**RESPONSE TO FURTHER ISSUES LETTER**

**PDA DEVELOPMENT PERMIT FOR MATERIAL CHANGE OF USE FOR MULTIPLE DWELLING, SHORT-TERM ACCOMMODATION, RETIREMENT FACILITY, SHOP, FOOD AND DRINK OUTLET, HEALTH CARE SERVICE, EDUCATIONAL ESTABLISHMENT, BAR, HOTEL AND INDOOR SPORT AND RECREATION AT 5 HERCULES STREET, HAMILTON**

**MEDQ REFERENCE: DEV2022/1323**

Figure 2 – Proposed Setback / Separation Distances to adjoining development at 19 Hercules Street

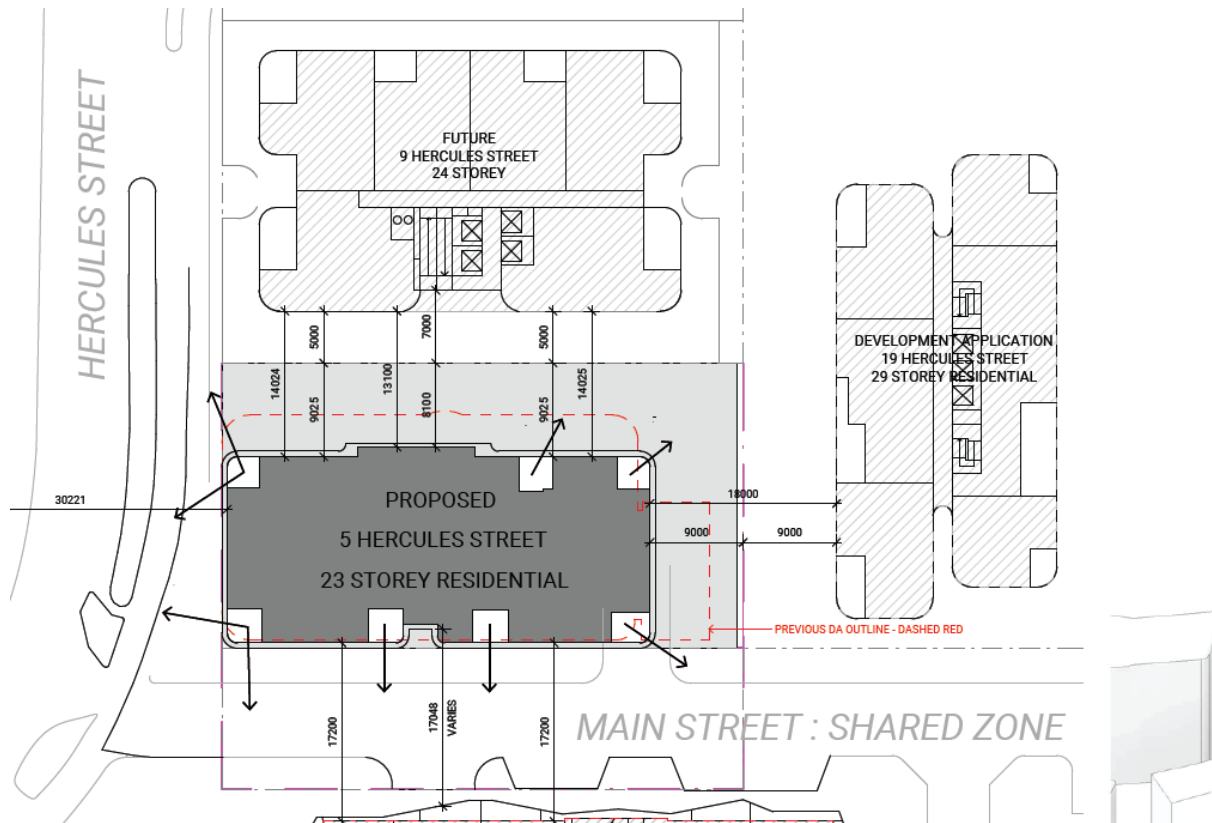
*The adjoining property (19 Hercules Street) has an approval for multiple dwelling units with podium and loading areas adjacent to the proposed recreation area on level 4.*

*Demonstrate how the proposed design responds to the adjoining development and respects privacy of both users.*

Whilst it's acknowledged that the adjoining property at 19 Hercules Street is subject to an existing development approval (EDQ Reference: DEV2020/1165), the apartment tower identified closest to the development is noted on the approved plans as 'indicative outline of future stage' and is currently not approved by EDQ and subject to change. However, the approved development does involve the construction of some retail tenancy space and servicing areas (non-habitable spaces) on ground floor level and are built to boundary (as illustrated in **Figure 1** below). Further, there is a mezzanine level containing non-residential uses which is setback 9 metres, and the outline elevations and 3D perspectives show that there is a podium intended for tower 4 (that interfacing the site) which is substantively built to boundary (meeting the proposed development's built to boundary outcome, consistent with the expectations of the Development Scheme).

With the exception of the proposed substation and MSB room (which are built to boundary), the proposed interface with the adjoining development at ground level is to carparking / manoeuvring areas which is to be screened by a 2m wide acoustic barrier and boundary landscaping. Furthermore, neither of the ground floor levels of the two developments are to be utilised for residential purposes and therefore will not result in any amenity to privacy issues. At the podium level, the built to boundary outcome has an appropriate interface to the indicative built to boundary podium represented on the adjoining development's drawings, or to the setback non-habitable mezzanine space. This does not result in any residential amenity impacts on either development.

**Figure 3** – Revised arrangements for visitor bike parking spaces on ground level

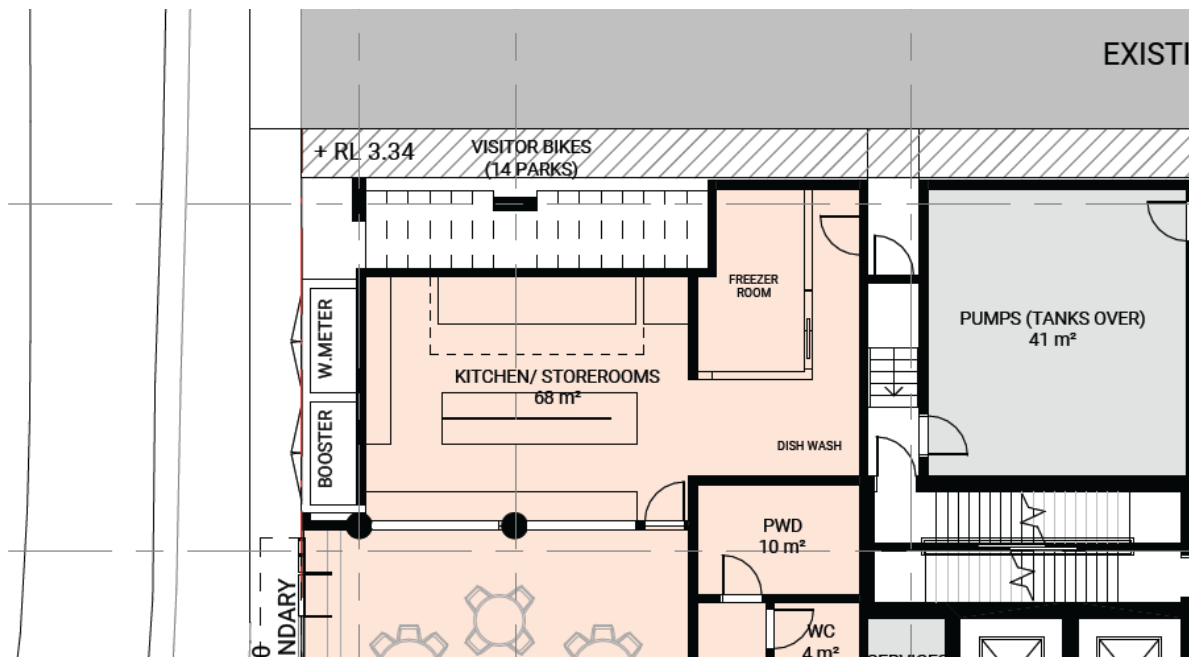
*The submitted Architectural Plans show that 14 of the visitor bike parking spaces rely on access via an easement along the northern boundary of the site. From review of the information provided, the easement does not allow access other than the purpose of inspecting, changing, altering, replacing, re-constructing and/or repairing pipes. In addition to this, there are concerns with CPTED with the bicycle access in this location. Submit amended plans relocating the 14 bicycle parking spaces elsewhere within the development or demonstrating an alternative accessway for the bicycle parking.*

The water metre and booster have been repositioned along the site's frontage to Hercules and allows for the 14 visitor bike parking spaces to be access without needing to enter the easement along the northern boundary (refer to **Figure 4**). Furthermore, these bike parking spaces are now clearly visible from the street frontage and not considered to be result in a poor CPTED outcome.
